Ross ISR Project USNRC License Application Crook County, Wyoming

RAI Question and Answer Responses Environmental Report Docket #40-09091

Prepared by:
Strata Energy Inc.
1900 W. Warlow Drive, Bldg A
PO Box 2318
Gillette, WY 82717-2318

MARCH 2012

Figure ER RAI GEN-1-1. Ross ISR Project Current Baseline Plan View.

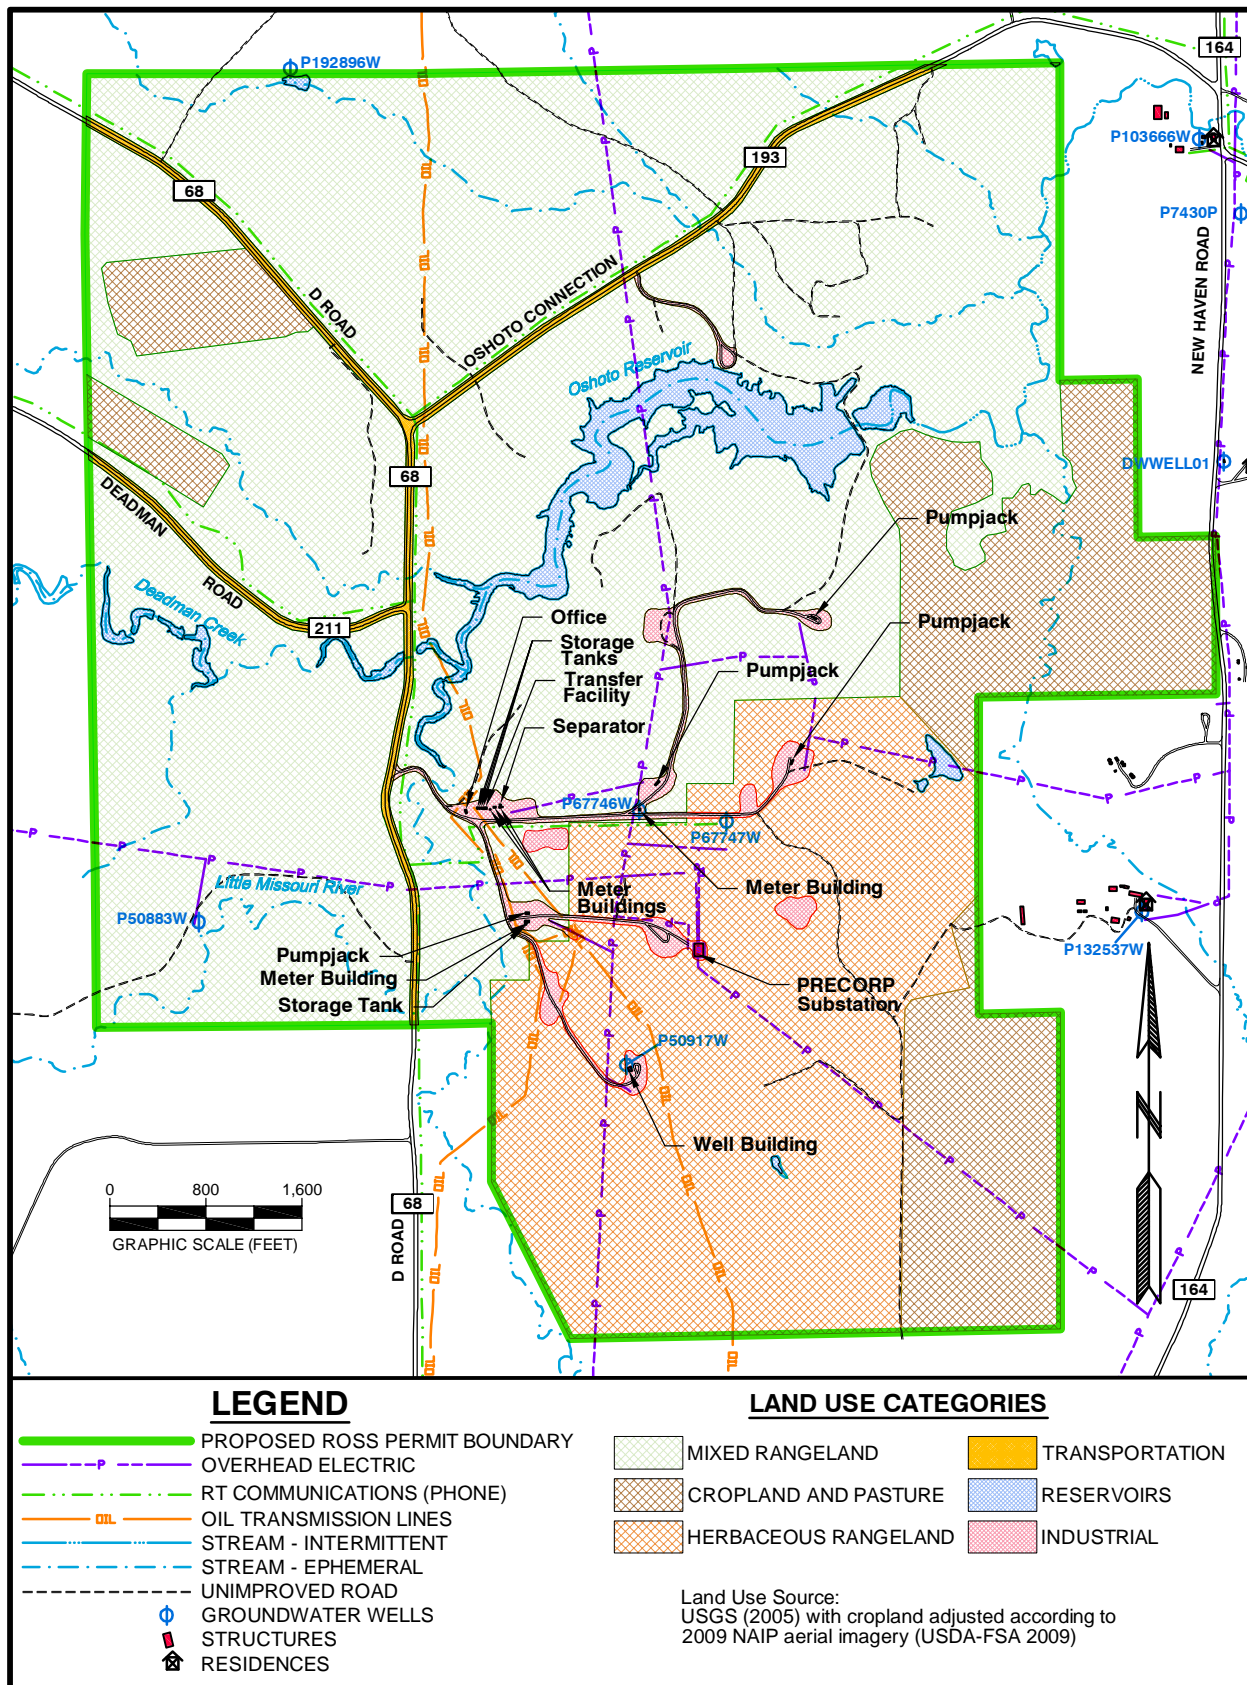
- A. *Please provide a current, baseline plan view of the existing Ross Project site, showing each of the physical (man-made) attributes listed below.*

Figure ER RAI GEN-1-1 depicts the current baseline plan view of the proposed Ross ISR Project area including land use, water bodies, streams, existing disturbance, nearby residences and infrastructure. As requested, this figure presents a more regional view of the proposed project area, including the entire proposed NRC license area, than ER Figure 1.2-5, which depicts only the CPP area.

Figure ER RAI GEN-1-2. Anticipated Facilities at the End of Construction.

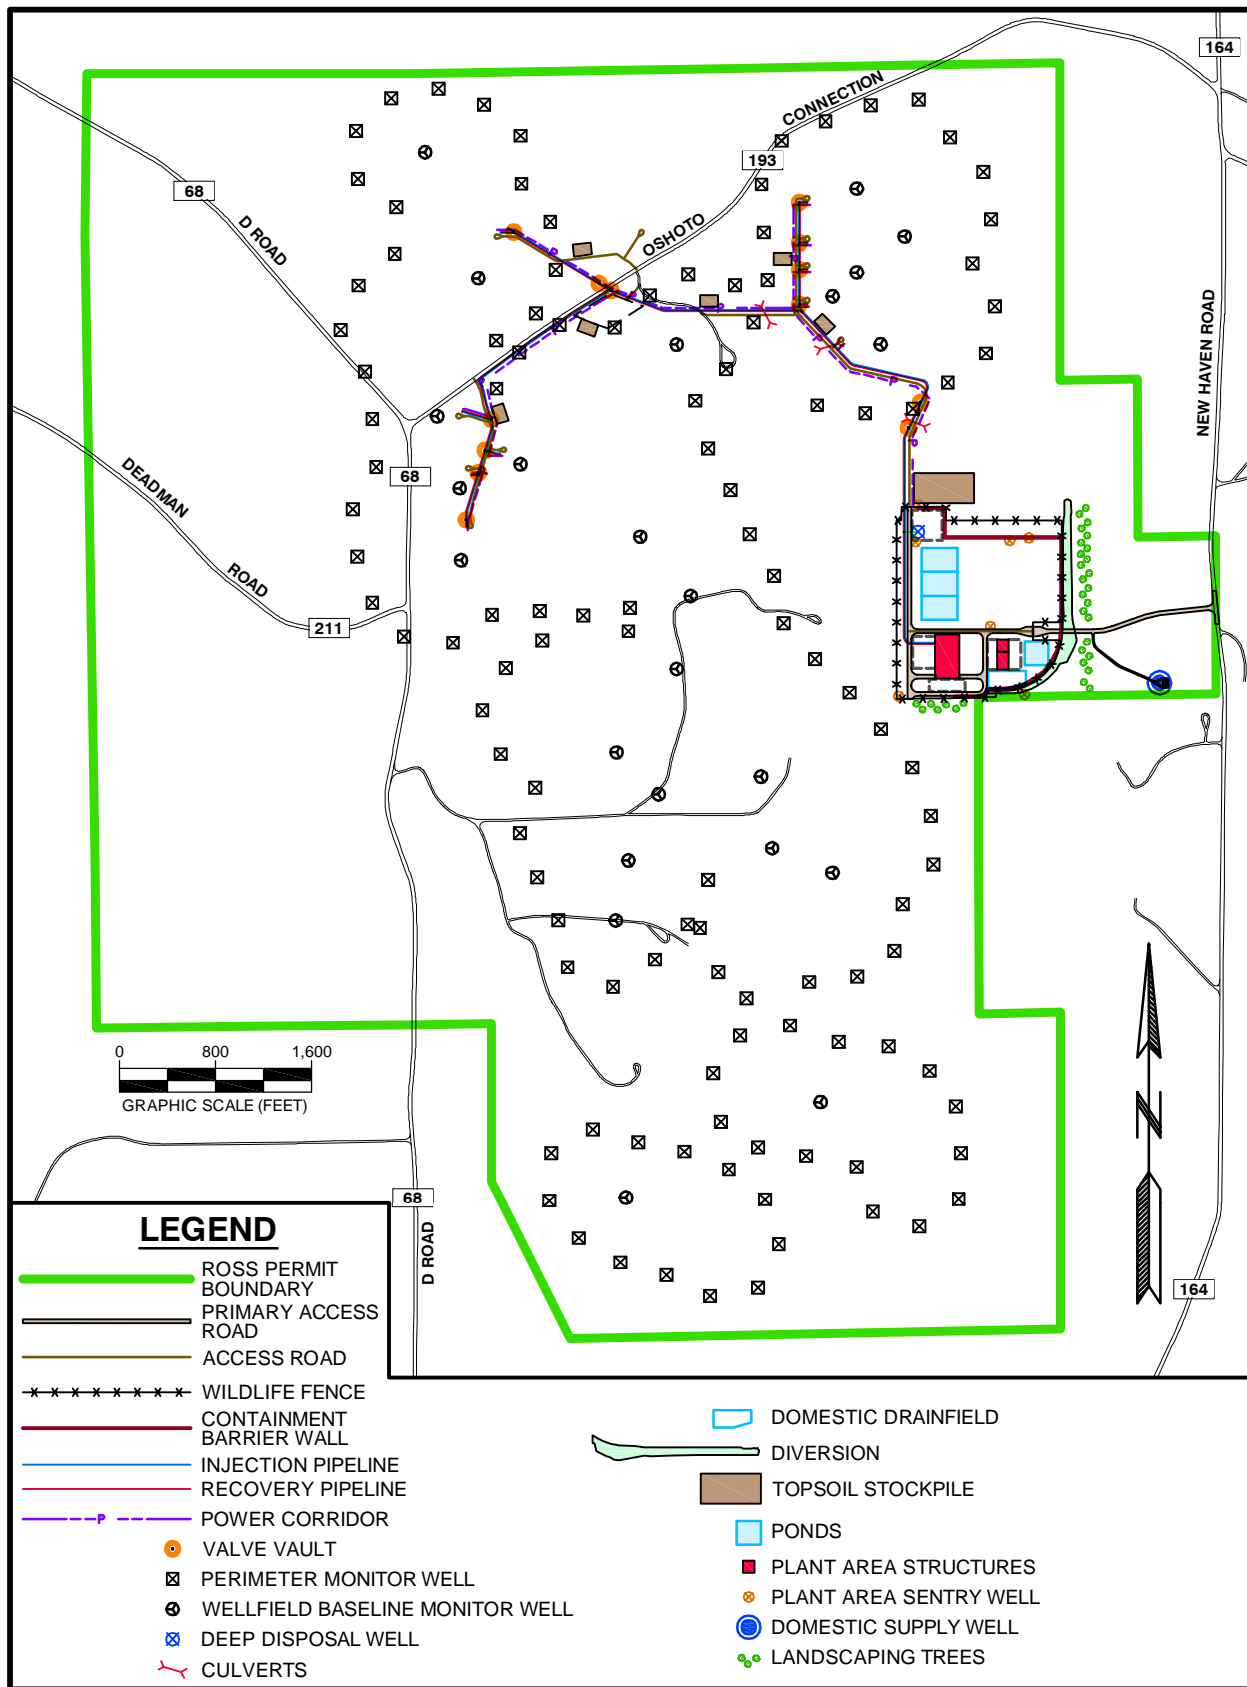
B. Please provide a plan view of the Ross Project site using the same scale and size as the baseline plan view and showing each of the physical (man-made) attributes listed below for each phase (i.e., construction, operation, aquifer restoration, and decommissioning) of the proposed Ross Project.

Figure ER RAI GEN-1-2 depicts the anticipated facilities at the end of facility construction. This time period is indicated in ER Figure 1.3-1 as the beginning of year 1 after regulatory approval. The facilities anticipated to be constructed include the primary access road, CPP area diversion, containment barrier wall, deep disposal well proximal to the CPP, domestic well and access road, lined retention pond 1, sediment pond, wildlife-proof fencing around the controlled area boundary, CPP, administration building and warehouse/maintenance building, and domestic drainfield. In addition, it is anticipated that the wellfield access roads, pipelines, valve vaults and power to the first mine unit will have been completed along with all of the perimeter and wellfield baseline monitor wells for both of the mine units. (Refer to ER Section 1.2.5 for a description of mine units; the wellfield modules will be divided into two mine units within the project area.) Construction and installation are also anticipated to have been completed on the module buildings in the first mine unit along with some of the production patterns; however, wellfield modules are not shown on this figure since most wellfield construction will occur after the end of facility construction.

Figure ER RAI CI-1-1. Potential Future Lance District Projects

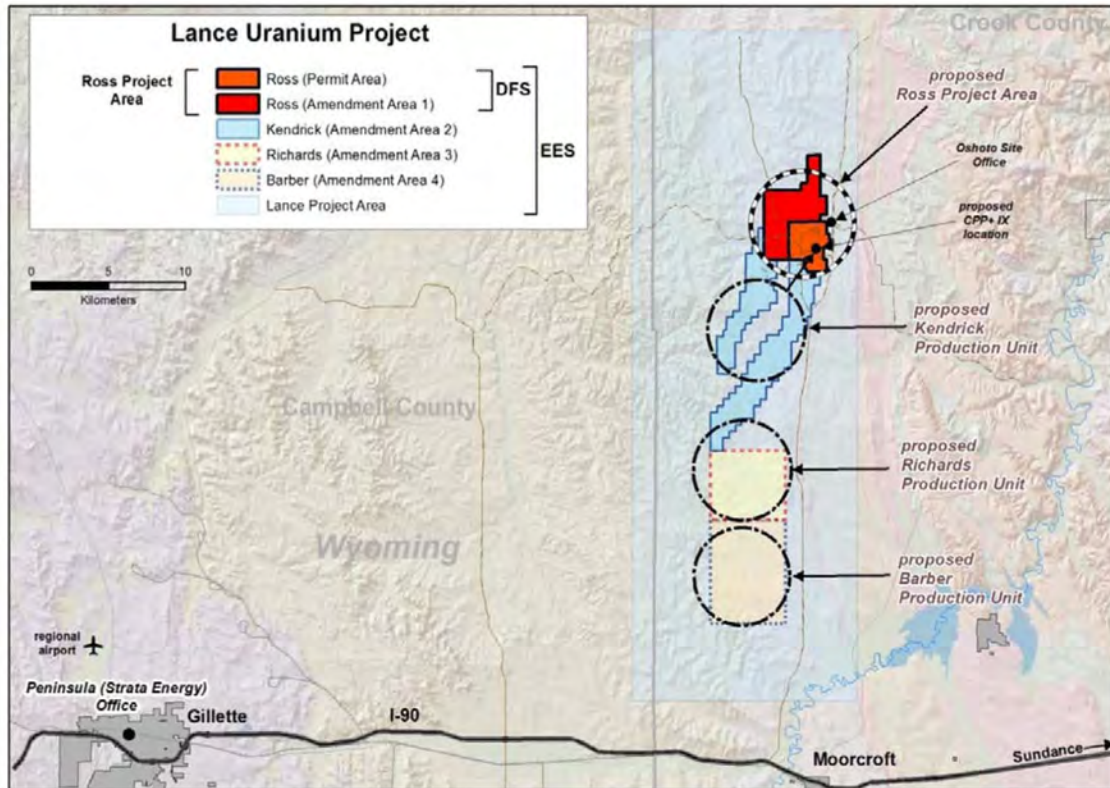
- A. *Please provide the proposed locations of the other projects relative to the Ross Project site.*

Figure ER RAI CI-1-1 depicts potential future Strata projects (license amendment areas) within the Lance District. As described in ER Section 2.2.7.1, Strata has identified significant uranium resources within the Lance District. The currently identified potential license amendment areas include an area adjacent to the proposed Ross project area (Ross Amendment Area 1), and the Kendrick, Richards, and Barber satellite facilities south of the proposed Ross project area (Peninsula 2011). Strata continues exploration drilling outside of the proposed Ross project area within the Lance District. As this exploration drilling continues, the number, location, and size of potential projects will likely change. Refer to the response ER RAI CI-1(B) for a discussion of the potential schedule of future Lance District satellite projects and to the response to ER RAI CI-2(B) for a discussion of potential cumulative impacts from these projects.

Figure ER RAI CI-1-2. Potential Lance District Development Schedule

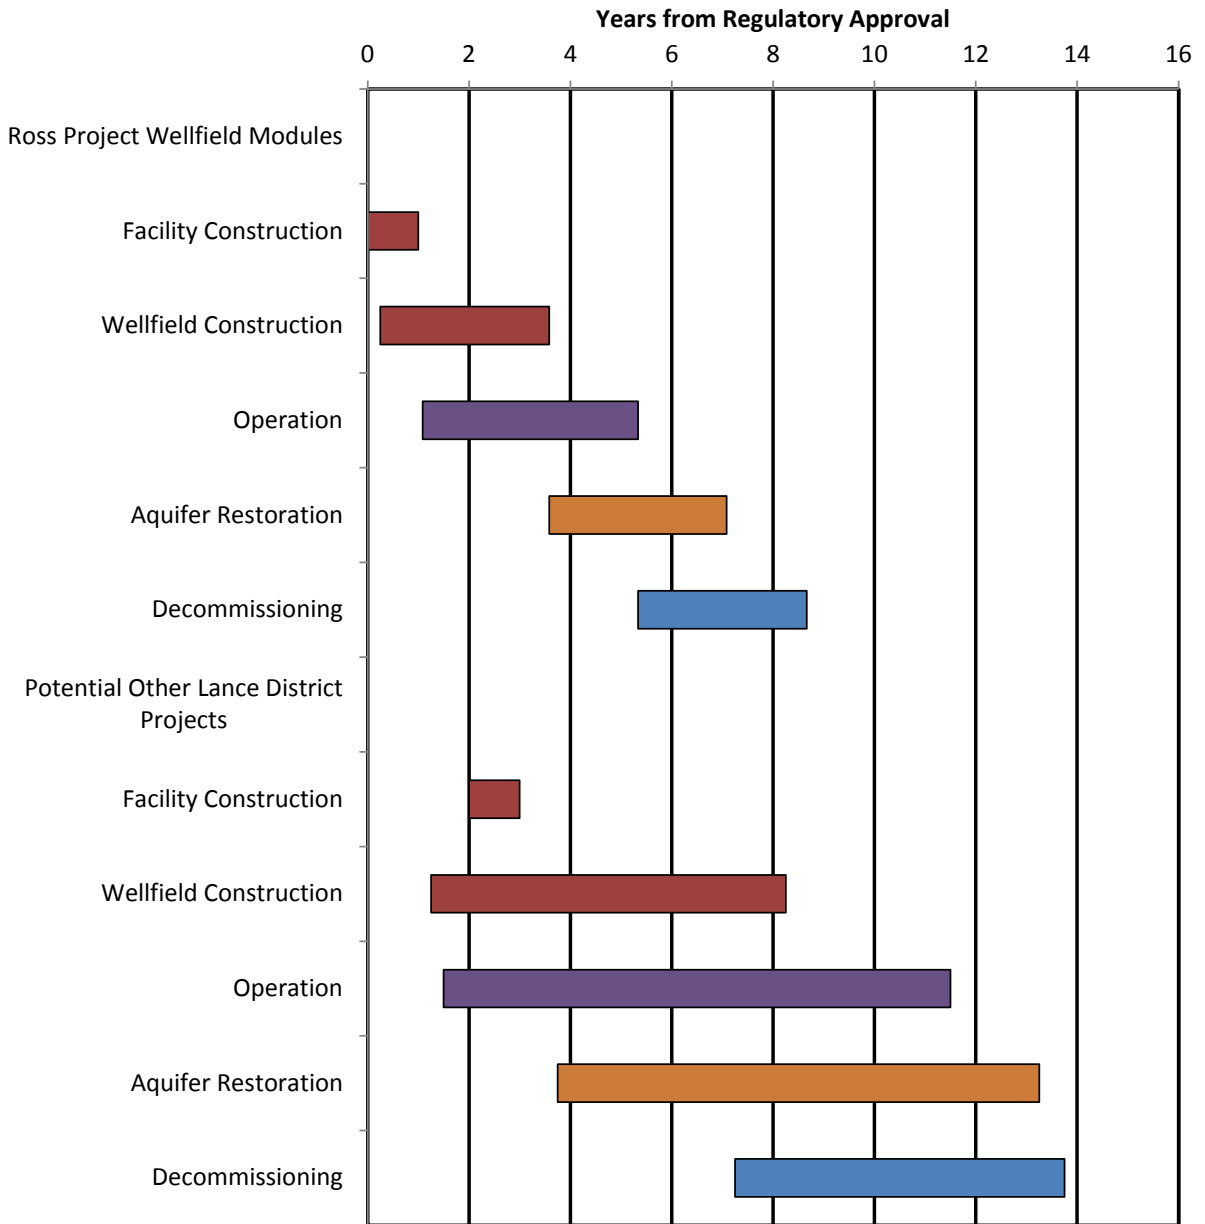
B. Please provide a schedule relative to the Proposed Action for these other projects and their activities.

Figure ER RAI CI-1-2 depicts the potential Lance District development schedule. This figure compares the potential schedule with the proposed Ross schedule as requested in the RAI. Reasonably foreseeable plans include steady-state operation of three satellite facilities. Based on potential resources in the Lance District, Strata anticipates that the total duration of ISR uranium production could be 11 to 18 years, including the Proposed Action. The potential Lance District development schedule assumes that wellfield construction in the first amendment area would begin 12 months after initial construction. The total duration of wellfield construction is estimated to be approximately 7 years. Facility construction, which would be primarily associated with the Barber Satellite Facility remote IX plant and associated ponds, is estimated to last 9 to 12 months. Operation of the amendment area wellfields is anticipated to last 10 to 17 years. Aquifer restoration is anticipated to begin approximately 2 to 2.5 years after the start of operation and last approximately 9 to 16 years. As with the Proposed Action, significant overlap is anticipated between operations and aquifer restoration, since aquifer restoration of individual wellfield modules would begin almost immediately
